SURFACE VEHICLE INFORMATION REPORT

J2915™

H-III5F Spine Box Update to Eliminate Noise

This SAE Information Report documents the problems with the 2002 regulated version of the spine box and defines a recommended solution to resolve the problem.

Figure 1 - Spine rocking on screws

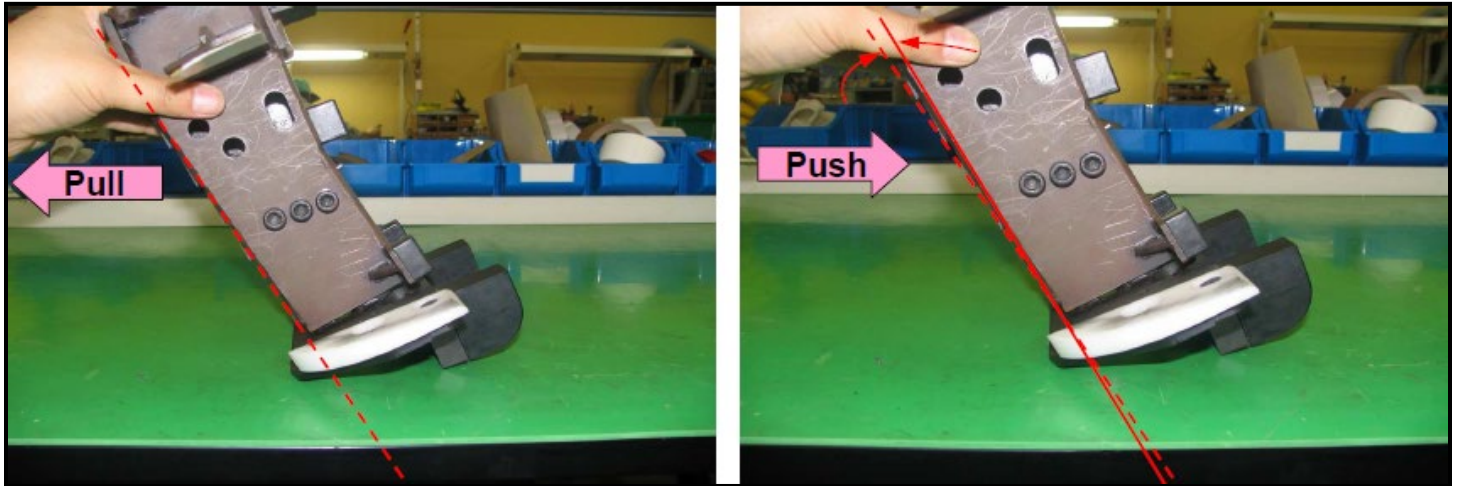
In the thorax region of the H-III5F, the spine box (880105-1000) is attached to the thorax load cell simulator (880105-328) by six 5/16-18 x 1/2 inch SHCS (item 29 on 880105-300). Since the holes in the spine box are 0.323 inch in diameter and the screws have a maximum diameter of 0.313 inch, there is always clearance between the screws and the spine box wall. As the H-III5F is exposed to the accelerations involved in sled or crash testing, the screws can loosen and the spine box will slip under the screw heads until it hits the sides of the screws. This motion produces high amplitude, high frequency mechanical noise on accelerometers within the dummy, which is an artifact of the dummy. A secondary effect of this rocking motion is that the spine box can move approximately ± 1 degree relative to the thorax load cell structural replacement (see [Figure 1](#)). This moves the head position relative to the pelvis fore and aft based on how the spine box is in contact with the screws.

Figure 2 - Sled data demonstrating problem

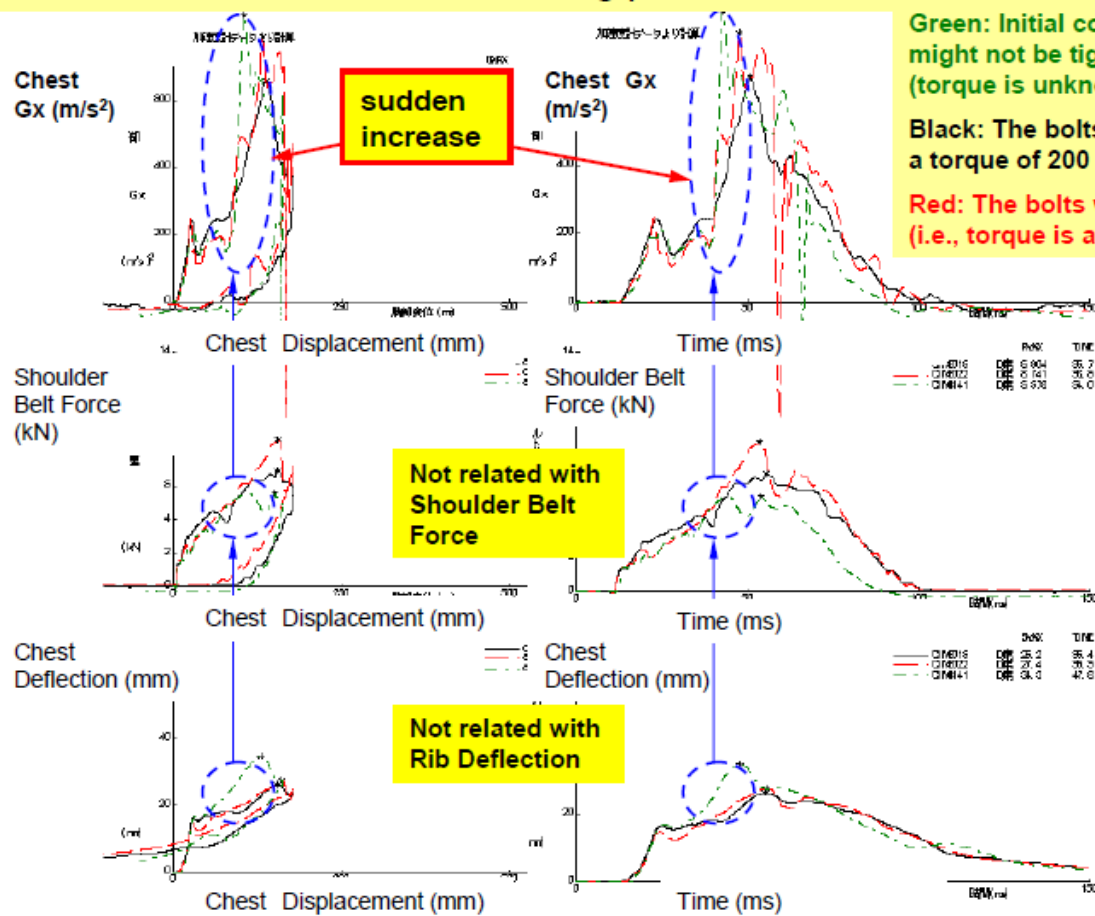
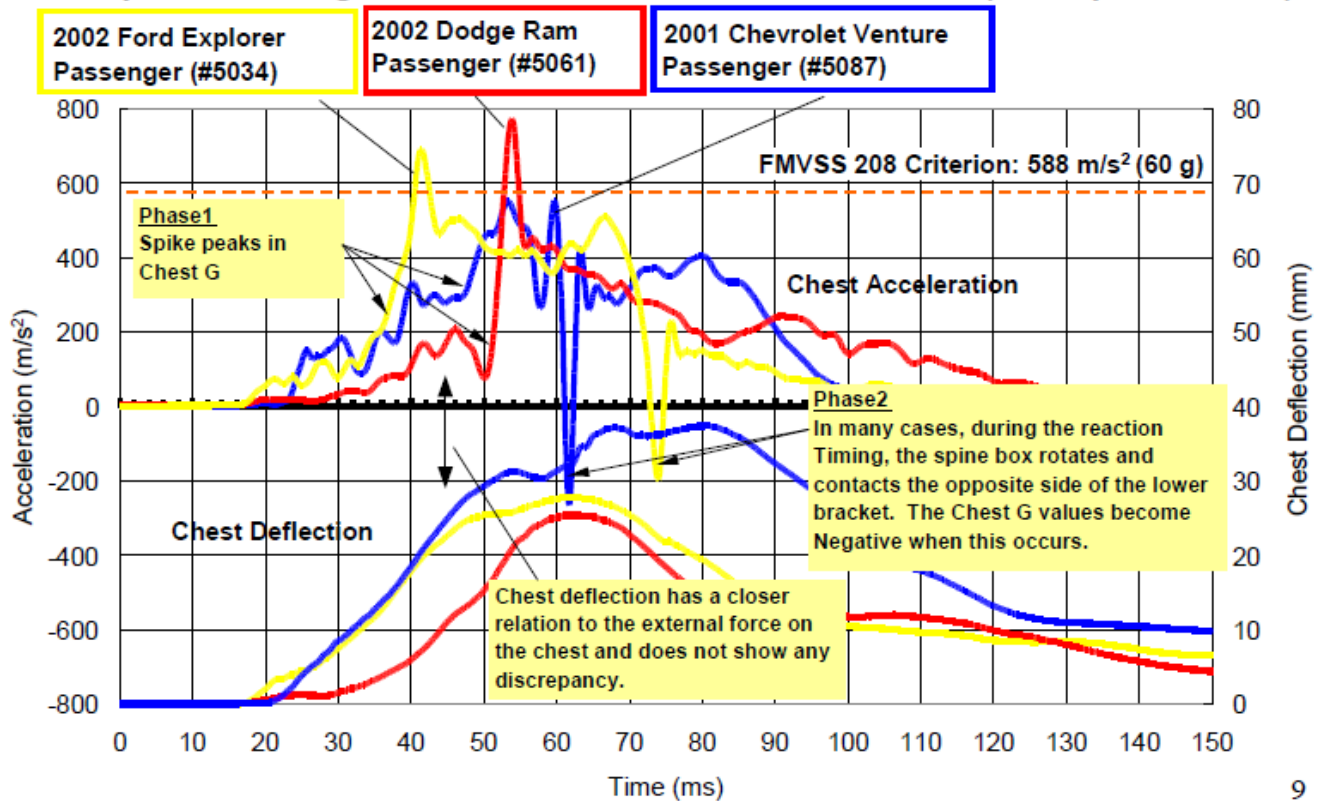
The data in [Figure 2](#) was presented at the December 11, 2007, meeting showing the noise spikes that were thought to be produced by the spine rocking during the impact event. This data was produced from a 35 mph belted sled test. [Figure 3](#) shows data that was presented at the same meeting showing noise spikes in 35 mph frontal rigid barrier tests that are hypothesized to be from the spine rocking as well.

The test data in green was obtained initially (with an unknown bolt torque) and we could not understand the cause of the abnormal peak-G. We tried to reproduce the phenomenon as shown with the resulting plots in red.
